[Docket No. FAA-2007-28661; Directorate Identifier 2007-NM-013-AD]

Airworthiness Directives; The Boeing Company Model 737-600, -700, -700C, -800, and -900 Series Airplanes

ACTION: Supplemental notice of proposed rulemaking (NPRM); reopening of comment period.

Figure 1

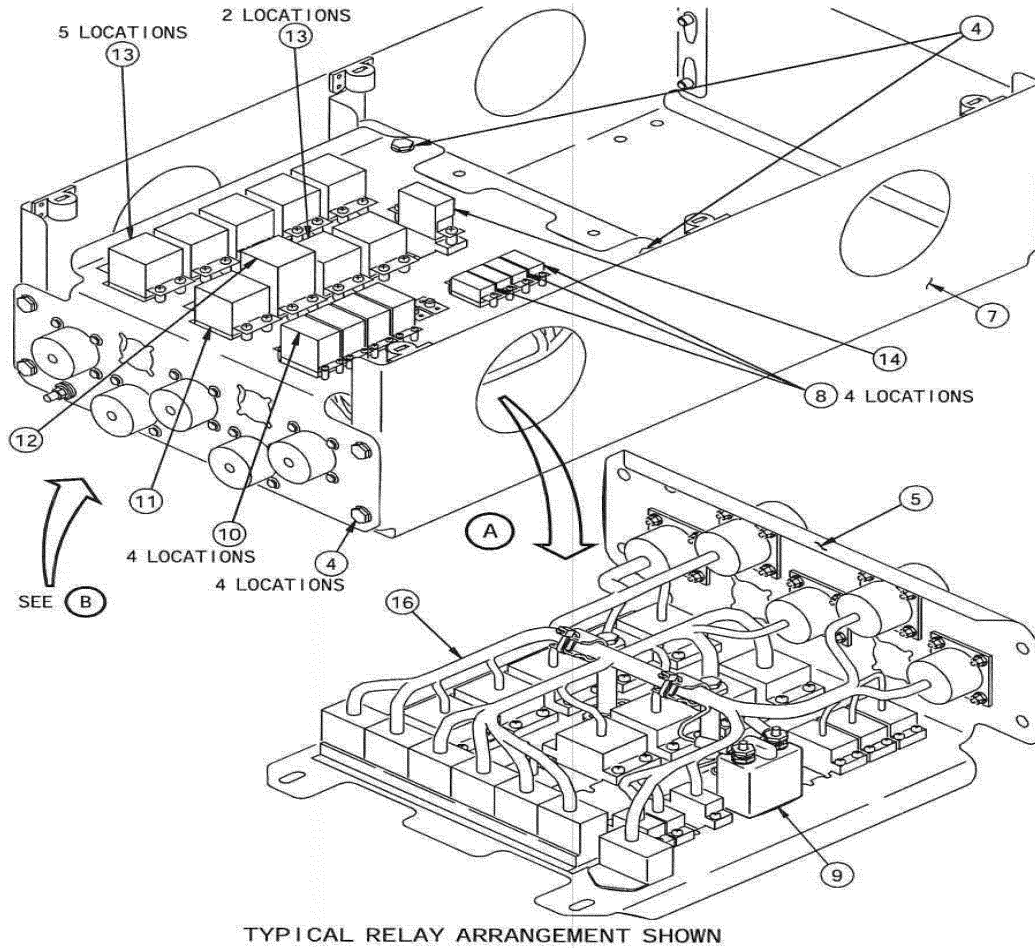
- Sheet 2 of 4 of Figure 11 of Boeing Alert Service Bulletin 737-28A1206, Revision 2, dated May 21, 2009, was inadvertently replaced with Sheet 2 of 4 of Figure 11 from Boeing Alert Service Bulletin 737-28A1206, dated January 11, 2006. That figure was corrected in Boeing Alert Service Bulletin 737-28A1206, Revision 1, dated January 30,

2008, and did not need to be changed in Boeing Alert Service Bulletin 737-28A1206, Revision 2, dated May 21, 2009. We have added Figure 1 in this supplemental NPRM to provide the correct Sheet 2 of 4 of Figure 11.
